STAFF RECOMMENDATION

2406 Barton Avenue

Application: New construction – addition

Description of Project: The applicant is requesting approval after-the-fact of an addition as it has been constructed, having deviated from plans approved by the MHZC and Staff.

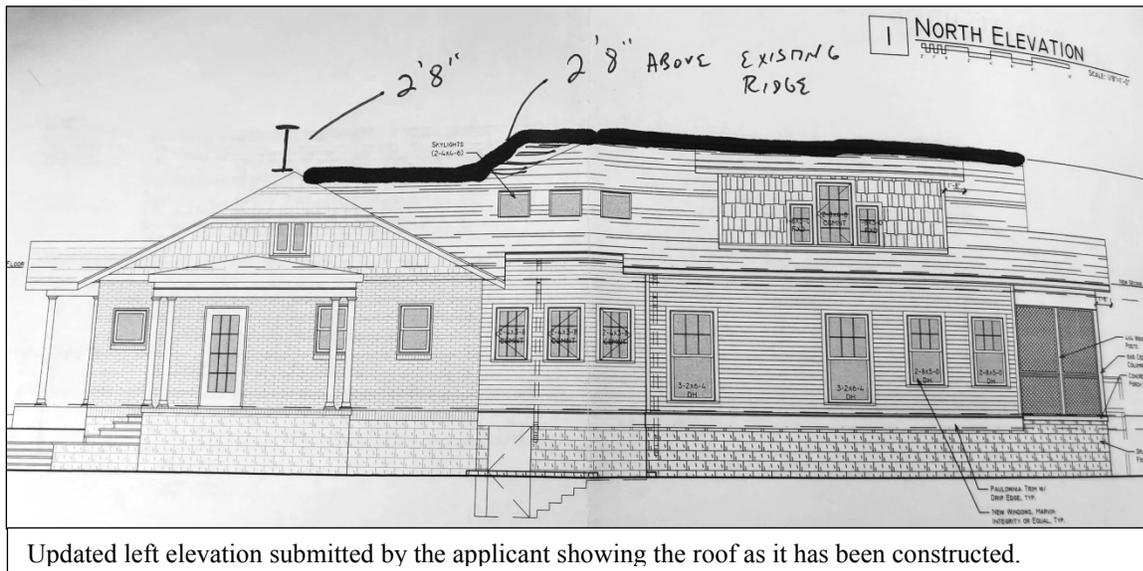
A full set of measured drawings of the addition as it has been built have not been produced, but the applicant has indicated that the addition extends back less than fifteen feet (15') from the original ridge before going taller, that it will rise at a pitch steeper than 5:12, and that the new ridge is two feet, eight inches (2'-8") taller than the original roof.

Taller additions have been approved when the additional height is minimal, the addition is not wider than the historic house, and the additional height happens so far back on the home as to be minimally visible, typically at forty feet (40') back from the front of the house. As constructed, the additional height is less than forty feet (40') back from the front of the house and is significantly more visible than anticipated. Staff finds that the roof as constructed is not compatible with the form of the historic house and that it does not meet sections II.B.1.a and II.B.1.b of the design guidelines.

Recommendation: Staff recommends disapproval after-the-fact of the revisions to the addition at 2406 Barton Avenue as it has been built, finding that the height and visibility are not compatible and that it does not meet section II.B.1.a and II.B.1.b of the design guidelines for additions to historic houses in Hillsboro-West End Neighborhood Conservation Zoning Overlay.

If the revisions after-the-fact are not approved, the applicant could submit plans for another revision to be reviewed by the MHZC at the next meeting, or they could alter what has been constructed to extend back fifteen feet (15') before going higher at a 5:12 pitch to make a new ridge two feet (2') higher, as the addition was approved.

Attachment B:
Elevations Approved by MHZC in July, 2017

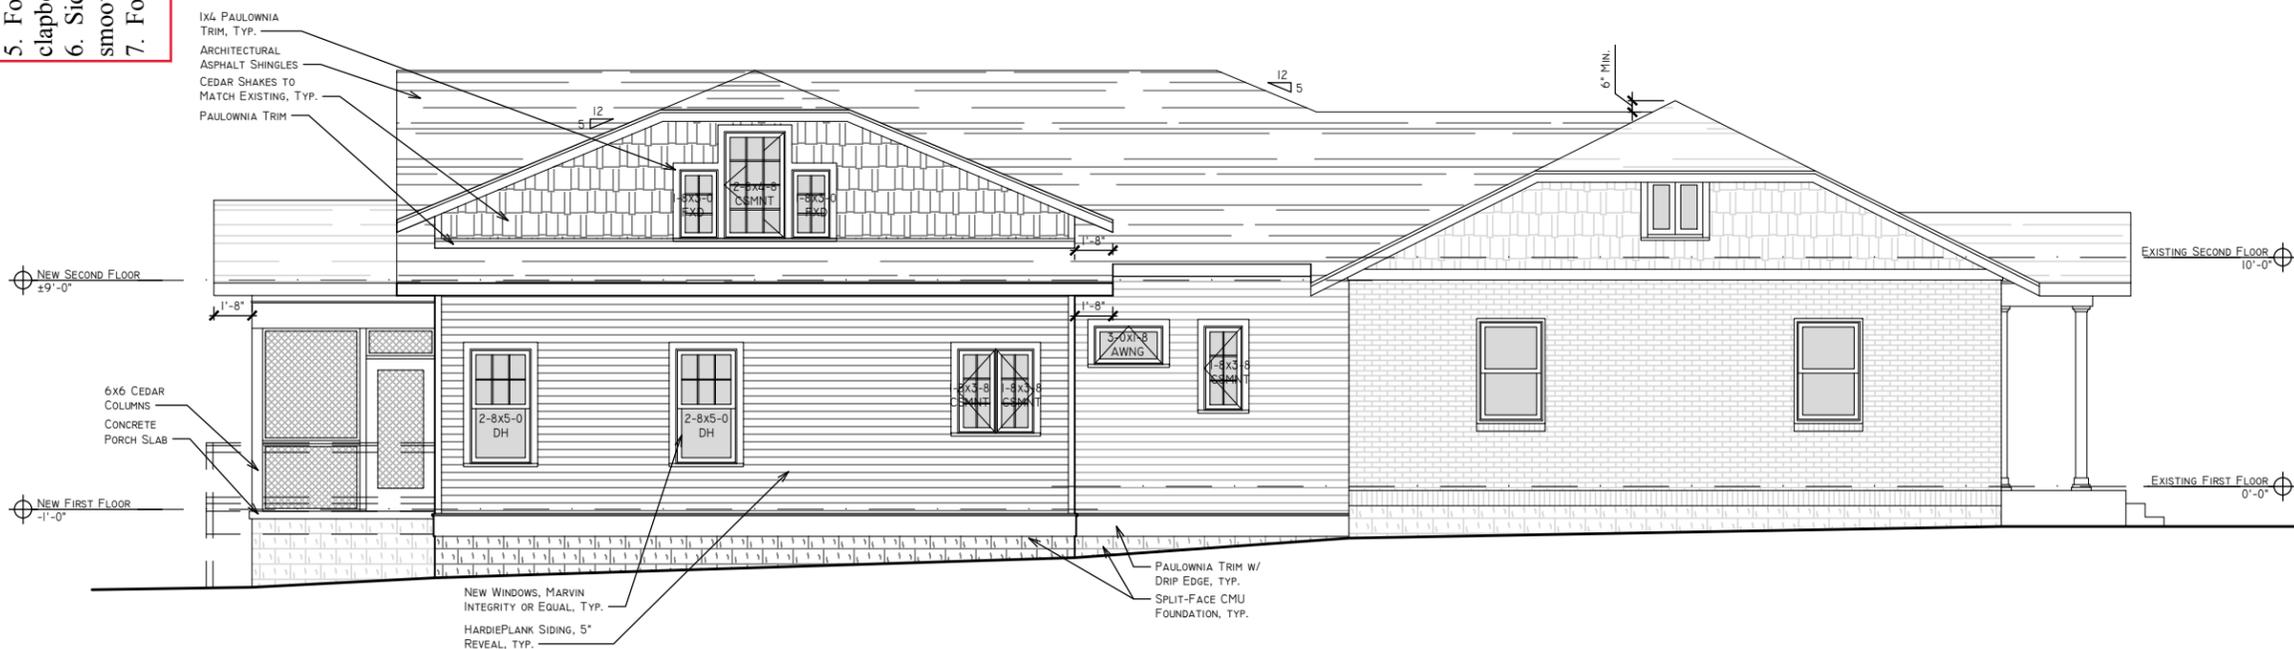
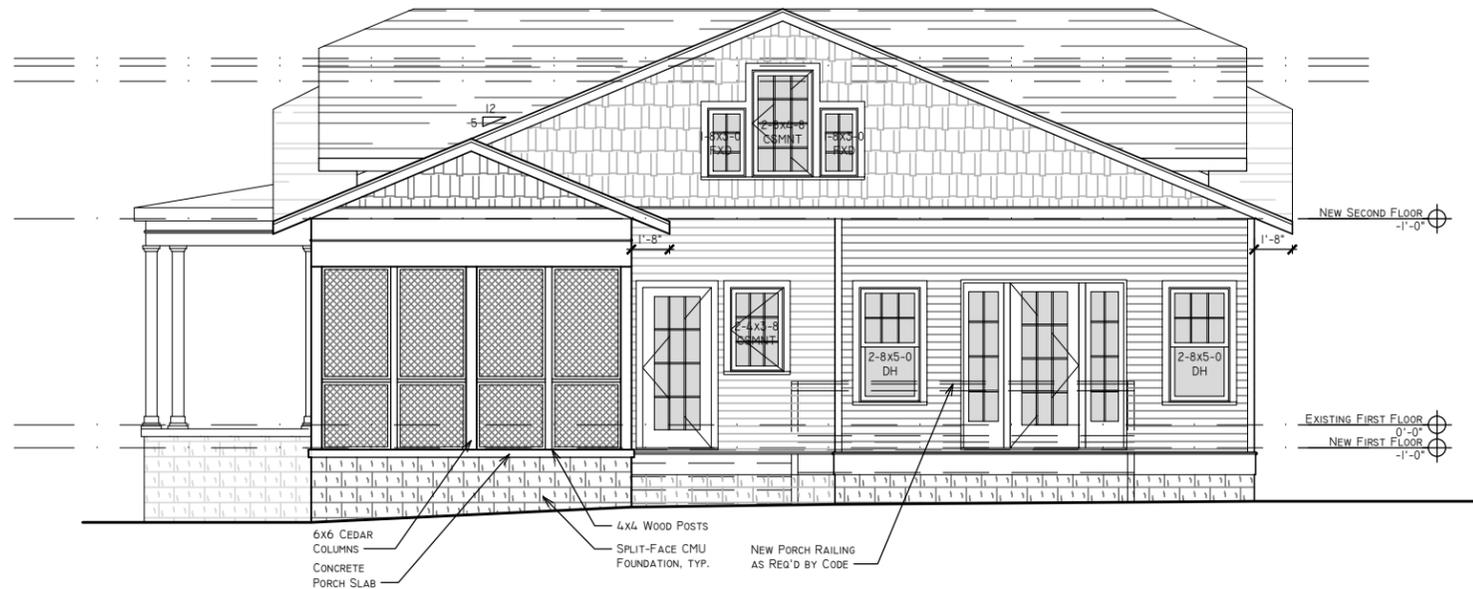
As it was originally approved, the roof of the addition was to be one and one-half story, with the first and second floors in the addition a step lower than the corresponding first floor and attic level in the historic house. The roof of the addition would tie into the rear slope of the original roof six inches (6') below the ridge and extend back fifteen feet (15'), then rise at a 5:12 pitch to make a new ridge one foot, four inches (1'-4") higher.

Left elevation from July 2017 approval showing new ridge one foot, four inches (1'-4") taller than existing and the floor level of stepped down from the historic house's floor.

Attachment C:
 Elevations Approved by Staff in March, 2018

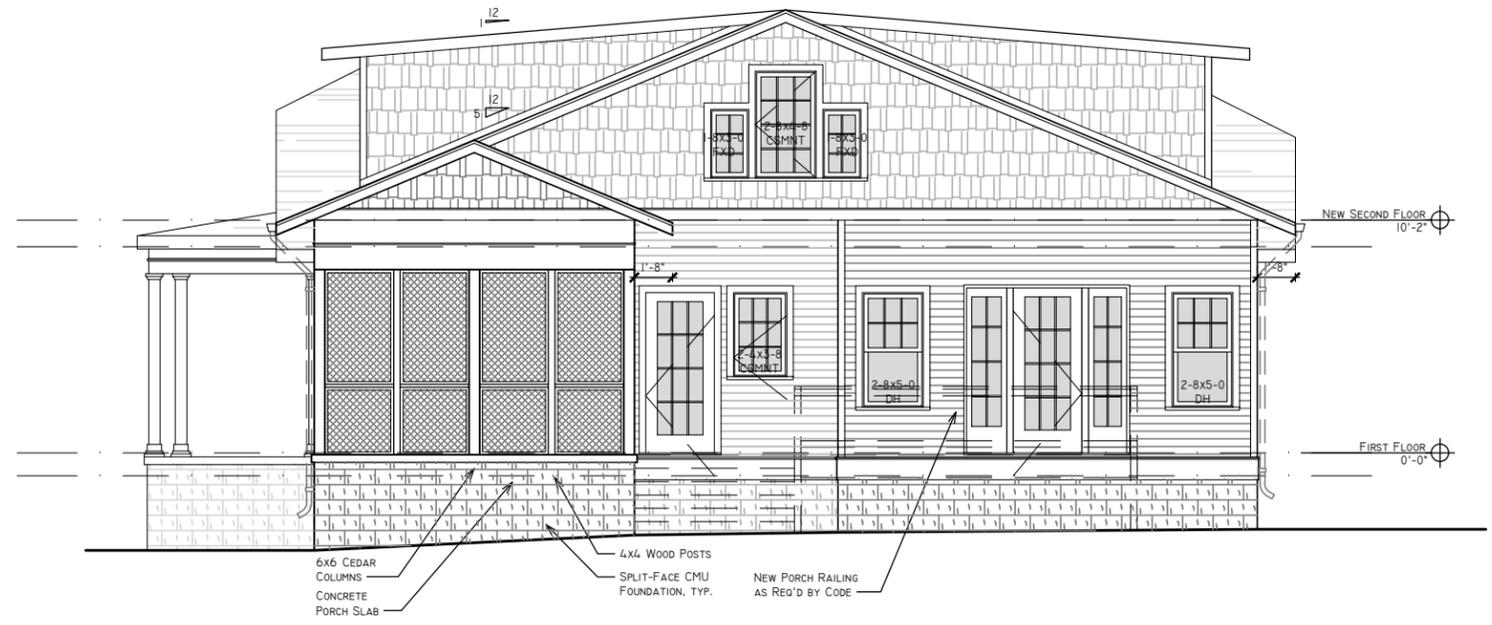
The addition was constructed without the first floor stepping down as it had been designed. In March of 2018 this error was identified and reported to Staff by the applicant, and after consultation with Staff a revision was approved administratively. Per the revision, the first floor would remain as it had been built and the second story would be modified. The roof would still tie into the rear slope of the original roof six inches (6') below the ridge and extend back fifteen feet (15'), and rise at a 5:12 pitch to make a new ridge two feet (2') higher. What were originally approved as gabled dormers would be changed to shed dormers to recreate space in the diminished upperstory.

Left elevation from March 2018 revision showing the new ridge two feet (2') taller than the existing and the floor level aligned with the historic house's floor.
